CRITICAL MEASURE BCA COMPLIANCE ASSESSMENT

To:	Hi Noon Ski Club Thredbo	Date:	4 February 2025
Attention:	Ziggi Krpan	Project Ref:	3430
From:	James Alexander	Revision:	Rev F FINAL
Project:	Hi Noon Ski Club Thredbo		
Purpose:	BCA Compliance Assessment of proposed upgrades to sanitary compartment and conversion of existing storage room to SOU

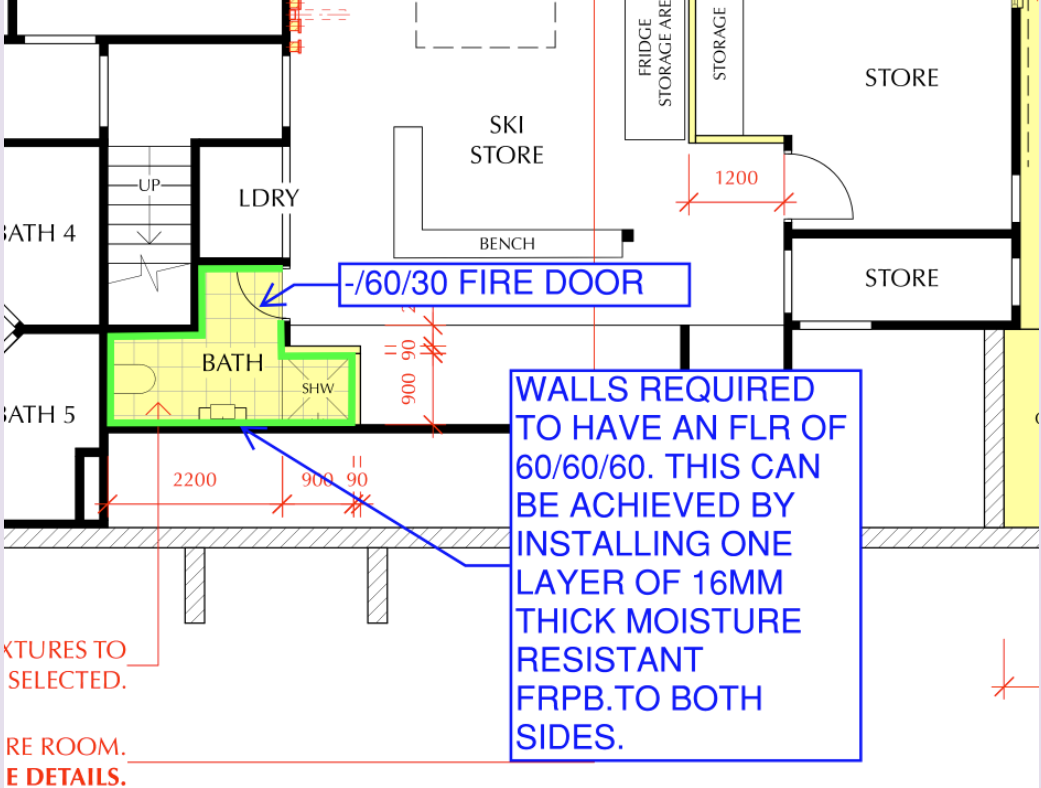
BCA CLAUSE	COMPLIANCE ISSUE	DESIGN RECOMMENDATION
BCA CLAUSE C2D2 SPECIFICATION 5 – FIRE RESISTING CONSTRUCTION	<p>The building is currently a Type C residential ski lodge located on the site. The building is class 3 throughout the ground floor and level one and therefore required to comply with the relevant requirements of Specification 5 Clause S5C24 for fire resistance levels.</p>	
	<p>External Wall: The external walls are required to achieve the following Fire Resistance Level (FRL) for load bearing walls:</p> <ul style="list-style-type: none"> • Less than 1.5m: 90/90/90 • 1.5m to 3m: -/-/- 	<p>The allotment boundaries have not been detailed within the architectural drawings. In general, the building is located at in excess of 1.5m from the Lot boundaries and hence are not required to achieve an FRL.</p> <p>Any new works to a floor/ceiling must achieve an FRL of 30/30/30 as a minimum.</p> <p>The walls of the sanitary compartment must achieve an FRL of 60/60/60. It is understood that the walls of the sanitary compartment and the proposed SOU are lined with 16 thick FRPB which would likely achieve the required FRL. The new walls of the shower area must be lined in the same manner.</p>

<p>Floors: The floor separating the two levels of the building is required to achieve a minimum 30/30/30 Fire Resistance Level.</p>	
	<p>Roof: The roof is not required to achieve a Fire Resistance Level as the building is a Class 3 building.</p>	
	<p>Bounding walls: The walls of the sanitary compartment are required to achieve an FRL of 60/60/60. Refer D3D9 below.</p> <p>The walls between the proposed SOU and the Ski store on the lower level are required to achieve an FRL of 60/60/60.</p>	
BCA CLAUSE C2D11 AND SPECIFICATION 7 – FIRE HAZARD PROPERTIES	<p>Carpets, floor and wall linings of all areas to be certified to comply with Spec C2D11 and sarking to comply with Spec 7.</p>	<p>Any new internal works are to comprise material linings with compliance fire hazard properties.</p>
BCA CLAUSE C4D3 – PROTECTION OF OPENINGS	<p>If the distance between an opening and the fire-source feature to which it is exposed to is less than 1.5m from a side or rear boundary of the allotment, 6m from the far boundary of a road, river, lake or the like adjoining the allotment, if not located in a storey at or near ground level or 6m from another building on the allotment that is not a Class 10.</p> <p>The allotment boundary is not nominated within the architectural drawings.</p>	<p>There are no openings in the proposed development located within 1.5m of an allotment boundary and hence the requirements of this clause do not apply.</p>

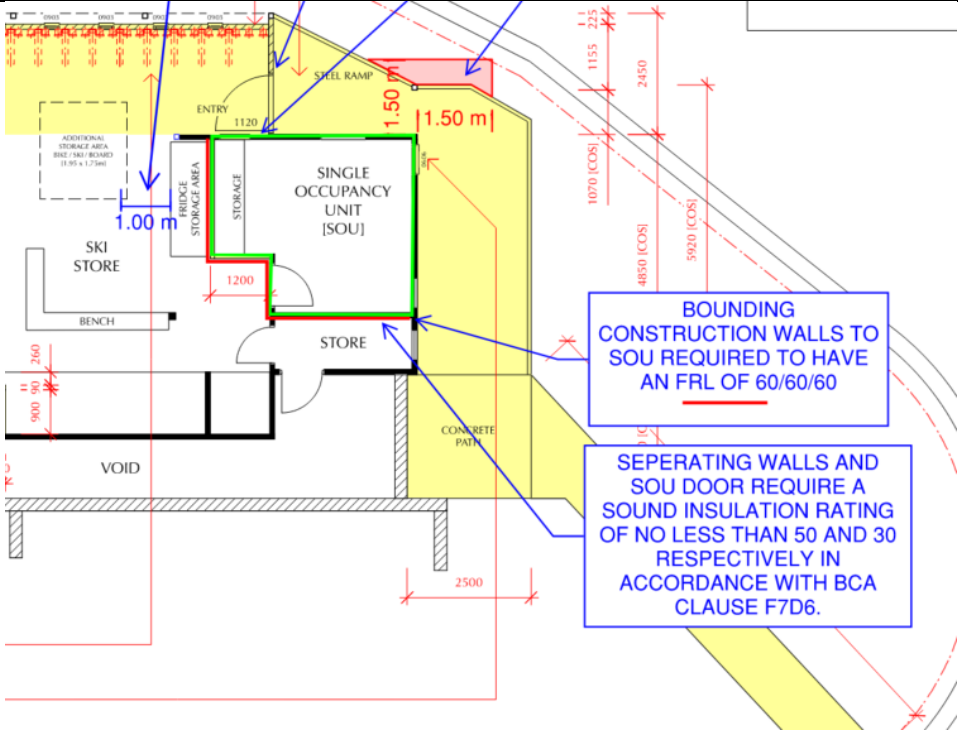
BCA CLAUSE	COMPLIANCE ISSUE	DESIGN RECOMMENDATION
	 <p>Figure 1 - Fire resisting requirements</p>	
<p>BCA CLAUSE D2D3 NUMBER OF EXITS</p> <p>BCA CLAUSE D2D5 - EXIT TRAVEL DISTANCES</p>	<p>In a building under 25m, one exit is required to be provided per level, the distance of travel to an exit or point of choice is required to be within 6m on the upper level and 20m on the ground floor level.</p>	<p>The sanitary compartment and proposed SOU are located within 20m of an exit.</p>
<p>BCA CLAUSE D2D7 - HEIGHTS OF EXITS, PATHS OF TRAVEL TO EXITS AND DOORWAYS</p> <p>BCA CLAUSE D2D8 WIDTH OF EXITS AND PATHS OF TRAVEL TO EXITS</p>	<p>In a required exit or path of travel to an exit —</p> <ul style="list-style-type: none"> • The unobstructed height throughout must be not less than 2m, except the unobstructed height of any doorway may be reduced to not less than 1980mm. • The unobstructed width of each exit or path of travel to an exit, except for doorways, must be not less than 1m. 	<p>The reduced height is located over the WC and therefore not considered a path of travel to an exit. The reduced ceiling height will however need to be addressed under F5D2.</p>  <p>Figure 2 - raked ceiling over WC is less than 2.1m over the WC.</p>

BCA CLAUSE F5D2 – HEIGHTS OF ROOMS AND OTHER SPACES	A minimum of 2.1m ceiling height is required to be provided in accordance with BCA Clause F5D2 to the subject sanitary compartment.	The extension of the compartment must include a 2.1m head height. The low head height under the stair will need to be addressed via a performance solution.
